## Hillcrest Elementary Parking Garage Facades

This exhibit shows an alternative for the west and south facades of the garage. Final design should be substantially similar to the submittal provided in the Council Agenda Item, or to this alternative shown below. The final design of the south and west parking garage elevations is subject to approval by the Planning Official in order to ensure adequate screening and quality design.

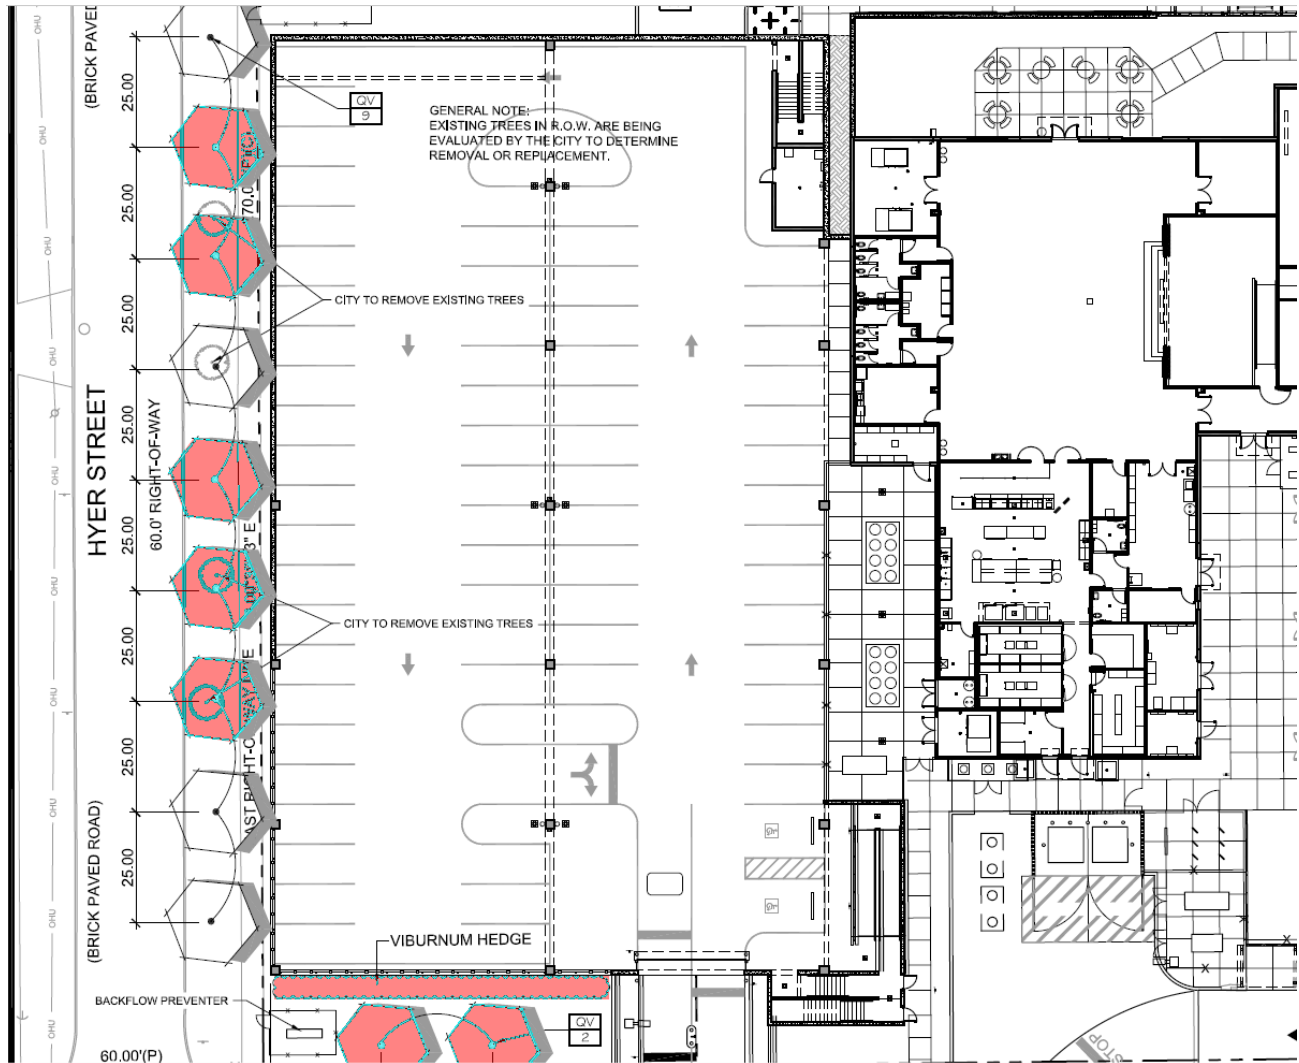
OCPS updated the plan to include 7 additional canopy trees to better screen the parking lot lighting, and a viburnum hedge on the south side of the building to better screen the face of the garage.
